SUBJECT: Pedestrian Trail, Capital High School Performing Arts Center CPD Project No. 18-3543, 2707 Conger Avenue NW

I have reviewed your request to install a gravel pedestrian trail without lighting, a deviation from the requirements for the type of neighborhood collector trail required per Section 4E, Trails or Shared Use Paths, of the 2017 Engineering Design and Development Standards (EDDS).

EDDS Deviation Request
Requested By	: SCJ Alliance - Ross Jarvis, PE Date: January 17, 2019
Telephone #:	360.3521465 Project Name/Number: Capital High School - Performing Arts Center
Project Locati	on: 2707 Conger Avenue NW Olympia, WA 98502
Describe Deviation Request:	See Attached
Reason for Deviation:	See Attached
List below all	l related documentation and include them as attachments.

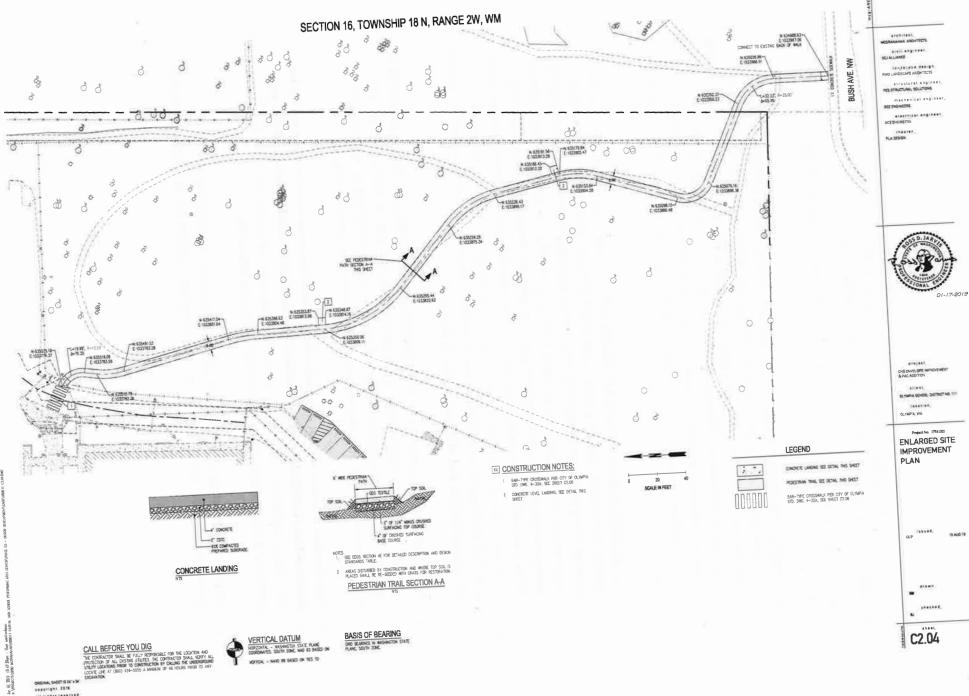
The applicant is requesting deviations from the standards of the City of Olympia Engineering Design and Development Standards (EDDS). The requested deviations are from Section 4E Trails or Shared Use Paths as well as Standard Drawing 4-2L for Trails/Share Use Paths. The trail in question is considered a neighborhood collector trail. The specific deviations from the neighborhood collector standards relate to trail width, surfacing, trail illumination, and unrestricted access. Specifically, the District requests the following deviations per Section 1.050 of the EDDS:

- A 6-foot trail width
- Crushed rock surfacing
- No trail lighting
- Existing secure gate at the school side of pedestrian trail (north side of trail)

- <u>Construction</u>: The path is located within a wooded, undeveloped and fairly steep area of the site. Construction of a standard neighborhood collector with 12 total feet of width (10-foot path and 2-foot grass shoulder), lighting and asphalt surfacing would require far greater impact to existing trees and slopes than the proposed modified trail.

- <u>Maintenance</u>. On-going maintenance of the standard trail, especially lighting, would also have more impact to the existing area.
- Hours of Use and School Site Safety The trail connects a residential area to the school. Use of the trail before and after school hours, for student access, is the primary purpose for the trail. Night use of the trail is not desired due to the isolated areas along the trail and not required for the functioning of the school site. In addition, unrestricted access during school hours and at night presents safety challenges for the operation of the school. Open access and trail illumination would only encourage trail use during those hours.

Overall, the proposed modified trail would provide superior protection of existing trees and slopes than the standard section and would provide for school site safety needs.

The benefits of having a gravel trail at this location, meeting the Recreational Pedestrian Trail standard in Section 4E of the EDDS, instead of the current informal steep dirt trail, are clear. Additionally, your proposal adequately address each of the criteria in Section 1.050 and is hereby **Approved**. This approval is specific to the proposed project noted above and the trail to be constructed consistent with the detail and alignment shown on the attached drawing C2.04. If you have questions, or need additional clarification related to these conditions, please feel free to contact Steve Sperr at <u>ssperr@ci.olympia.wa.us</u>, or (360)753-8739.
